# SERVICE BULLETIN

SB No. 031

SPECIAL INSPECTION - SAFETY HARNESS (NEGATIVE 'G' STRAP)

FIG. 1  
PORT SEAT DRAWN STARBOARD SIMILAR

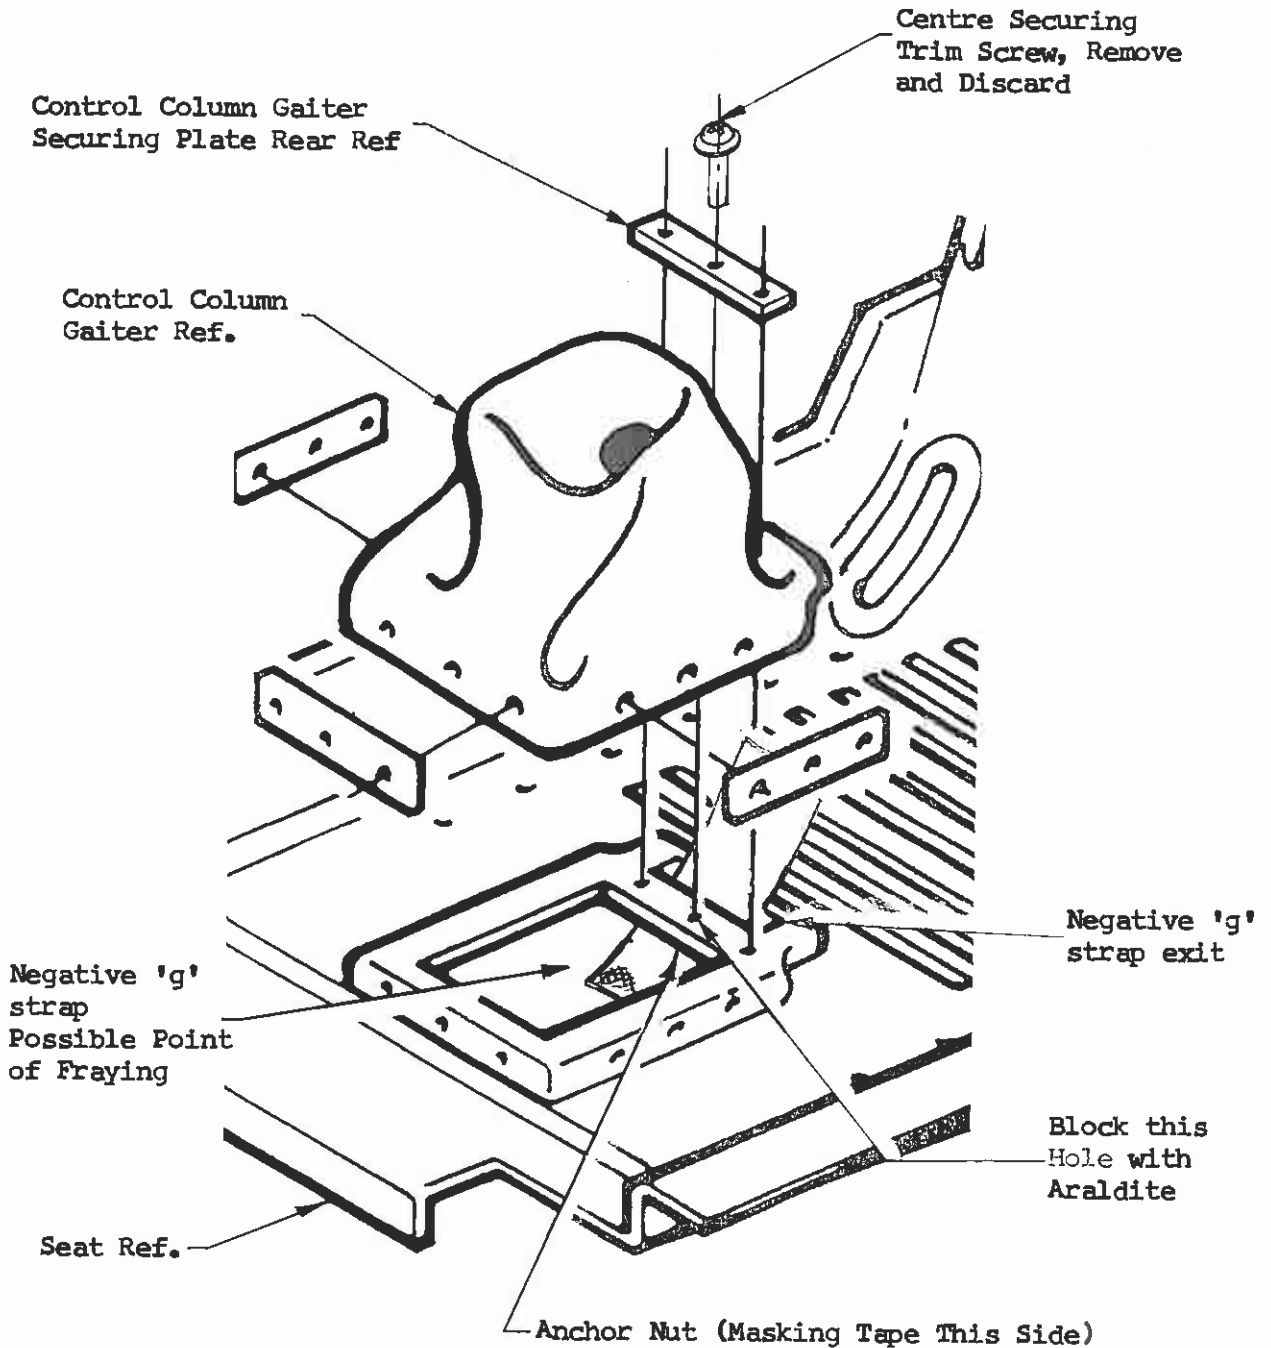
A case has occurred where the safety harness negative 'g' strap chafed against one of the screws securing the base of the control column gaiter.

1. Loosen the control column gaiter from around both control columns, then remove gaiter retaining plates.
2. Inspect negative 'g' strap for fraying, especially in the area of the aft retaining plate's screw. Ref. Fig. 1, page 3.

3.
  - i) If negative 'g' strap is satisfactory proceed to step 4.
  - ii) If negative 'g' strap is found to be damaged, remove seats as per standard practice, and renew negative 'g' strap. Then proceed to step 4.
4. Cover the bottom of the centre hole, i.e. anchor nut lower face as indicated on Fig. 1 with masking tape or similar.
5. Fill hole with Araldite Rapid or equivalent adhesive.
6. After curing, remove tape, smooth top surface and restore finish, i.e. paint black.
7.
  - i) If seat removed proceed as per 7 ii) otherwise refer to step 8.
  - ii) Replace seat and other items disturbed during implementation of this Service Bulletin. Re-assembly is opposite to dis-assembly. Ref. step 3 ii).
8. Re-assemble gaiter to seat. Re-assembly is opposite to dis-assembly. Ref. step 1.
9. Enter in logbook - S.B. 31 Part A or B, as applicable, accomplished.
